Comments on CDN/24/0005 and 0011

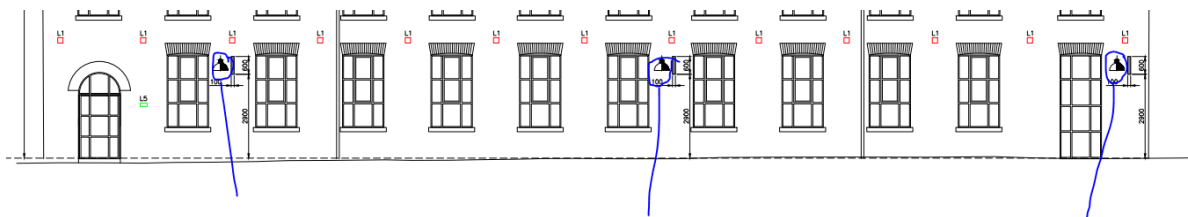
Also the drawings show fuse connection units which add further external clutter - can these be located internally. The elevation also seems to show what appears be three external projecting signs does this align with the proposed / approved signage that has been discussed with Michael?

The drawings show electrical feeds to **former** signage proposals that are now superseded by the submission of updated proposals via the separate applications. For clarity, drawing H_O - J369-LEXA & LEX2A should be omitted and for external building mounted lighting proposals refer to previously submitted JDA drawings 353 PD 1007 - 1010 (all rev P2)

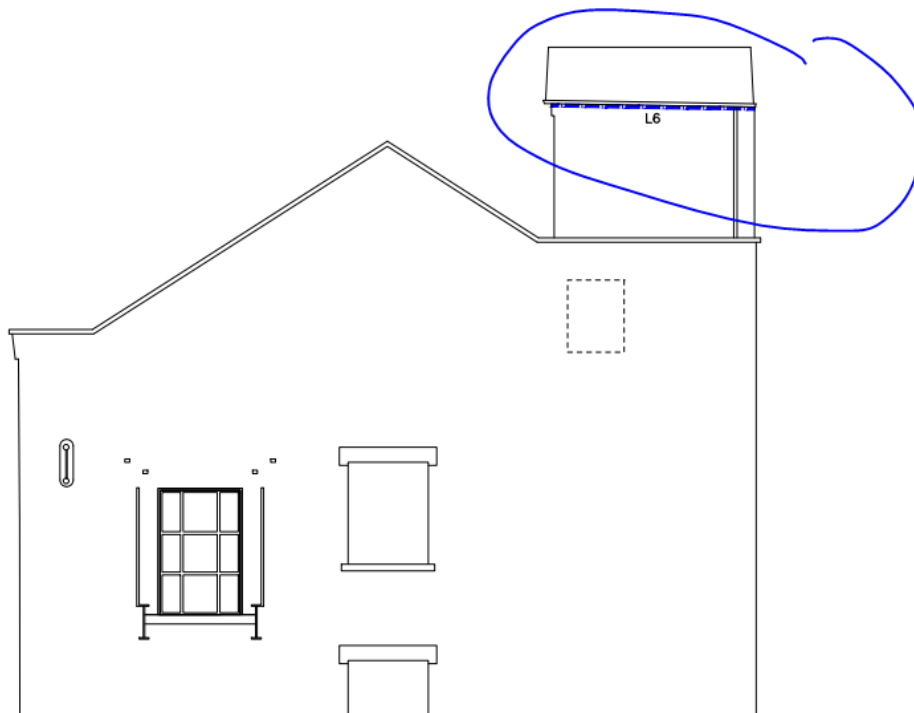
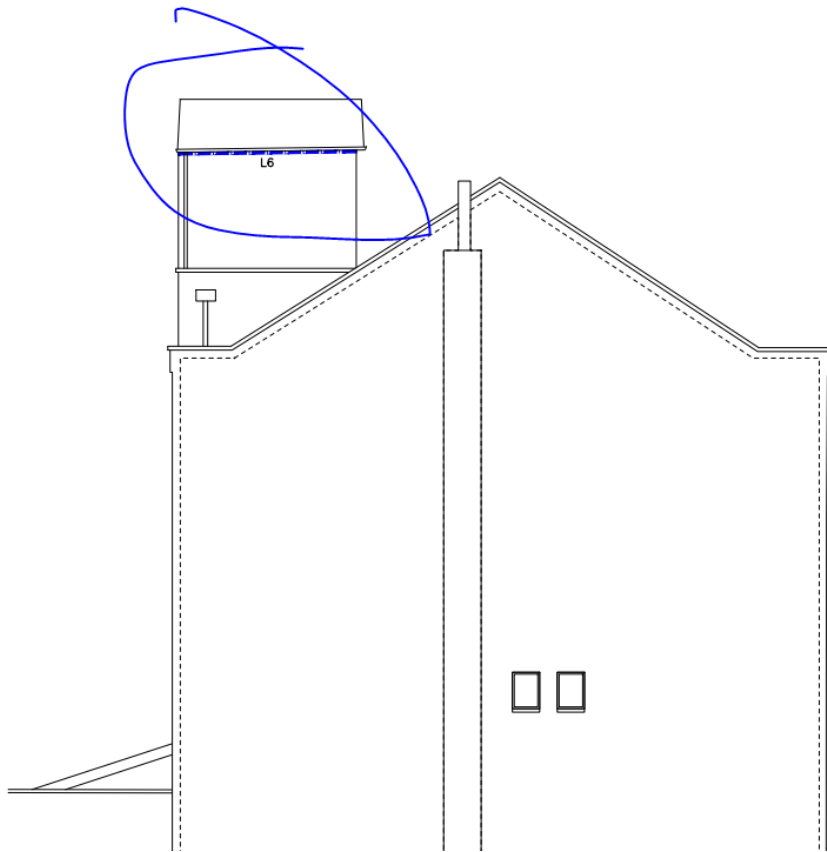
There is reference to high level LED lighting around the lift shaft again can this be removed from the condition discharge dwgs. Has this been agreed as part of the signage application?

As above, this was shown on JDA drawings submitted and approved as part of NMA application. This is to provide illumination to mural zone on lift overrun.
